Piston Replacement for the 2002 – 2005 Ford Explorer

Tech Tip

#104

#6512987

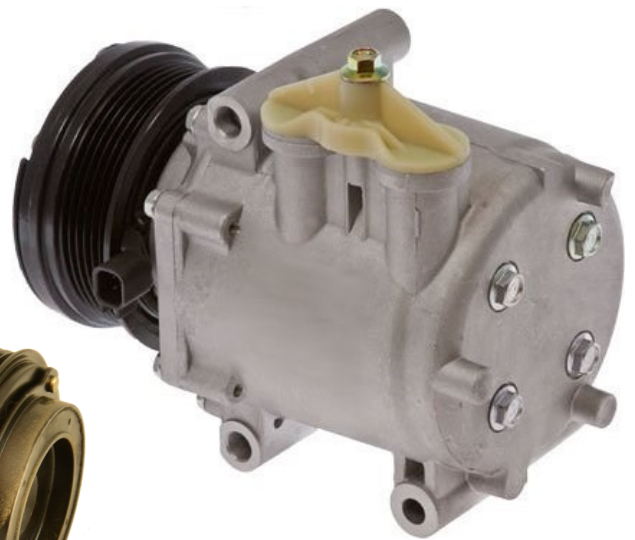
The piston compressor is a direct bolt-off, bolt-on replacement for the scroll style compressor. gpd's piston design is more tolerable of debris left in the A/C system and performs better at lower RPMS than the O.E. scroll.

All gpd compressors come with the correct amount of oil for the A/C system. No matter which compressor is chosen for replacement, gpd strongly recommends that the condenser is replaced and the system is flushed.
